CBD BUG

The CBD BUG is seeking your assistance in improving the proposal by Brisbane City Council to provide a link between the Kedron Brook Bikeway (KBB) and the TMR-delivered North Brisbane Bikeway (NBB).

Please find below the feedback of the Brisbane Central Business District Bicycle User Group (CBD BUG) regarding the BCC project concept plan for the North Brisbane Bikeway: (NBB) Bridge St to Kedron Brook (also known as the "Western Branch" / "Wellington Diversion").

Figure 1

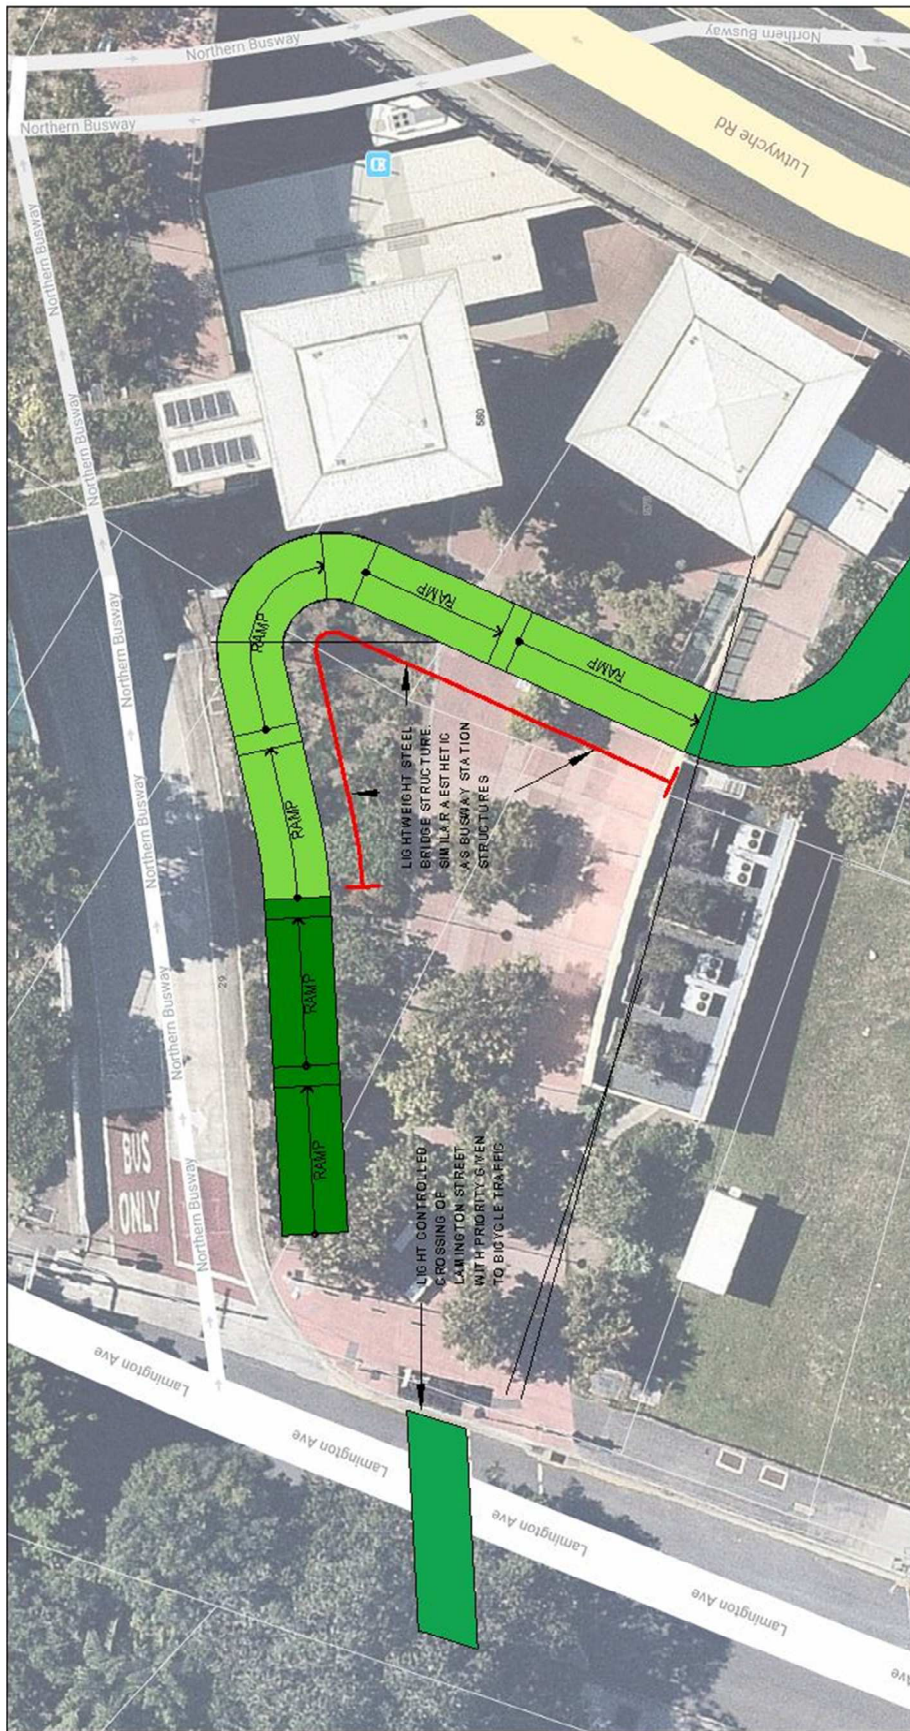
Currently between Bradshaw Park, Lutwyche and the Lutwyche Busway station, Lutwyche road ped/cycle underpass, BCC is proposing to upgrade/widen the footpath along Bradshaw St. While the CBD BUG commends the intent of such a measure its effectiveness as a piece of cycling infrastructure is unclear. This effectiveness will also be undermined as a mixed-use development is currently proposed on the formerly TMR owned land on the corner of Bradshaw St & Lamington Avenue. The CBD BUG has therefore proposed an alteration (figure 1) in the form of a ramp. BCC officers have confirmed that this option is practical and feasible. However they discarded this option to reduce the project delivery time, as the ramp requires co-operation between council and state.

A ramp in this location would be both aesthetically pleasing and practical, if designed correctly. It would be a much better and safer solution than the current BCC plan of a steep shared pathway past a number of shopfronts. It would be more convenient for people riding bicycles, and remove the conflict with people walking on the Bradshaw St path. It would also allow a safer, more convenient alignment for the crossing of Lamington St.

- The CBD BUG is of the view that a ramp should be built between Lamington Ave and the busway underpass (refer Figure 1) in preference to a widened footpath, for the following reasons.
 - This ramp would provide a significantly better and safer connection than a widened footpath.
 - The proposed development on the corner of Lamington Ave and Bradshaw St will effectively minimise the benefits of the widened footpath (to bicycle traffic).
 - If the Wellington Diversion ends up being well used, the capacity of the footpath next to the new building by the busway station will quickly be exceeded.
 - A ramp would be more appealing to riders and therefore a more effective use of money.
 - This footpath widening involves removal of a number of street trees, which typically generates a degree of community opposition

Figure 6

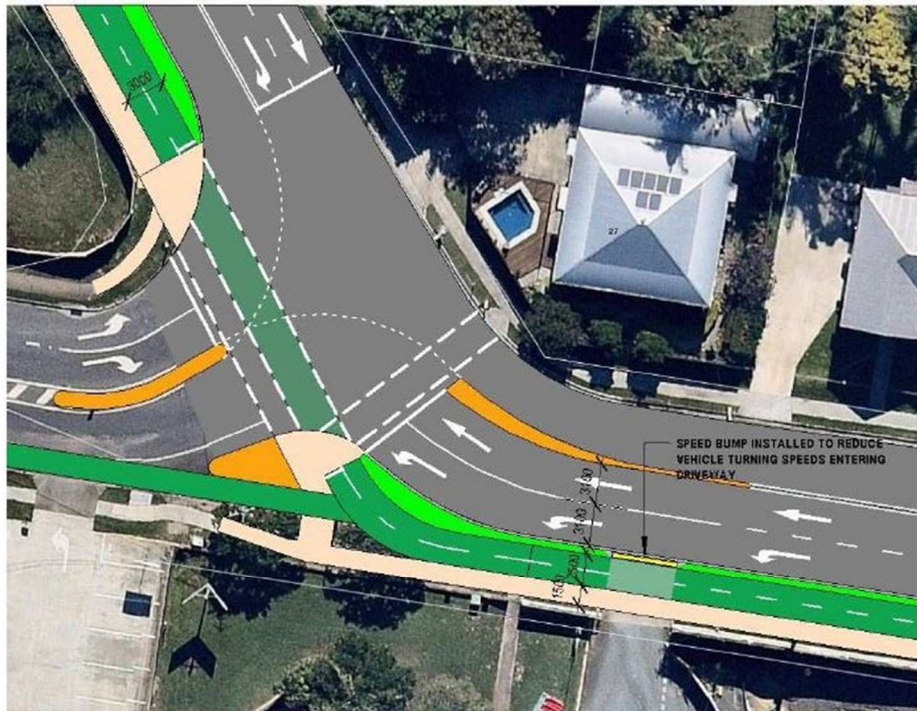
- The CBD BUG views the currently BCC proposed shared path along this section as a highly unsatisfactory solution.
- A shared path would not provide consistent messaging for bicycle movements
- Instead, the CBD BUG has the following proposal (refer Figure 4)
 - 1.5m pedestrian path (as per the Aust Roads minimum)
 - 2.5m cycle path (as per the Aust Roads minimum)
 - 0.5m verge/barrier
- This proposal is only slightly wider than the current BCC proposal of 3.0m concrete path and 1.0m of verge/barrier (total 4.0m)
- The CBD BUG proposal is very similar to what currently occurs along Brisbane St, Toowong (refer Figure 5)
- Design considerations and restrictions for vehicle access must be placed on the development occurring at the former church site.
